Positioning of Chain Link Fence at Drainage Ditches and Revision to Standard Roadway Construction Detail CD-32

August 14, 1990

MEMORANDUM
All Design Units

ATTACHMENT NO. 1

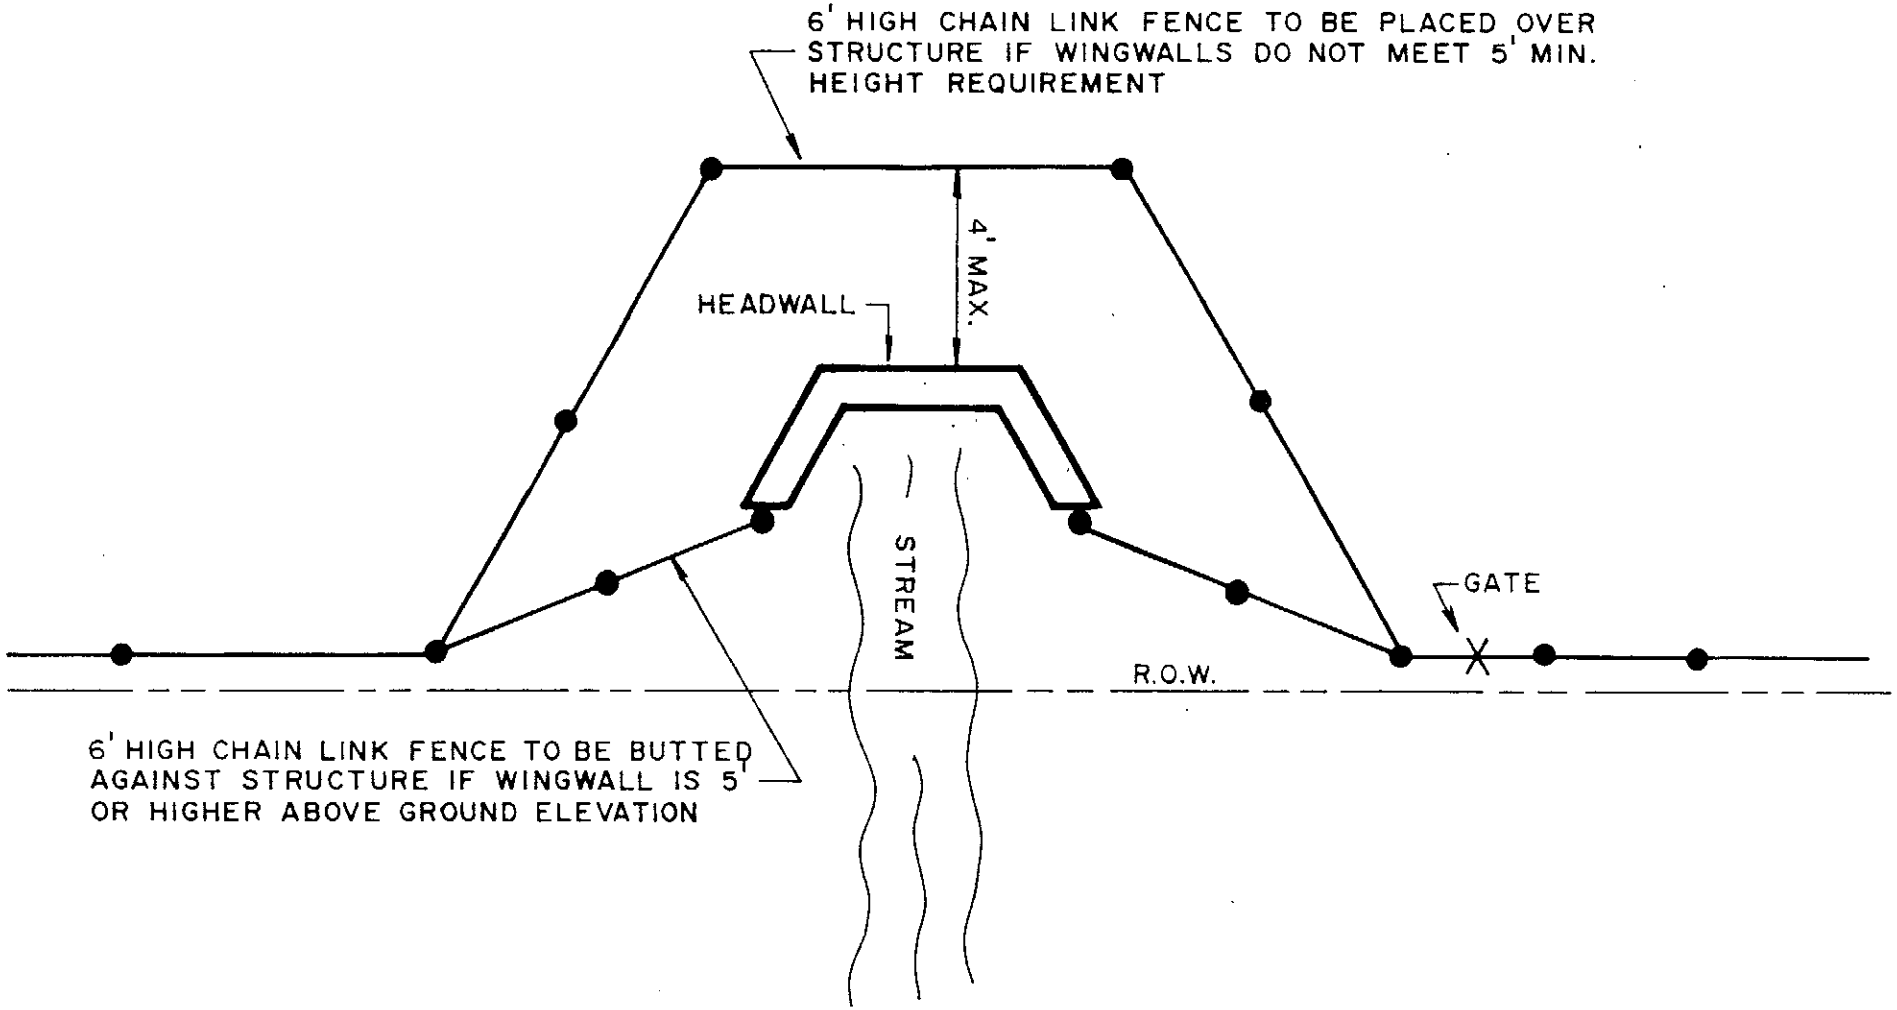
When positioning chain link fence, designers shall avoid crossing streams, drainage ditches, and other water crossings. Upon encountering headwalls or culverts with a wingwall height of less than 5' above ground elevation, designers shall align chain link fence to extend over and behind the structure as shown on Attachment No. 1. Upon encountering headwalls or culverts with a wingwall height of 5' or higher above ground elevation, designers shall align chain link fence to butt against the wingwalls of the structure as also shown on Attachment No. 1.

A 3' wide gate shall be provided to allow access of maintenance personnel. The approximate position of the gate shall be as shown on Attachment No. 1.

CD - 32.5

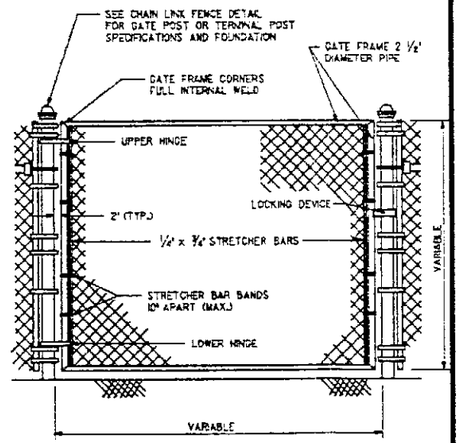
A detail of the 3' wide gate has been added to Construction Detail Sheet CD-32 as CD-32.5 and shall be added to all projects where chain link fence is to be constructed in the vicinity of drainage ditches and other water crossings.
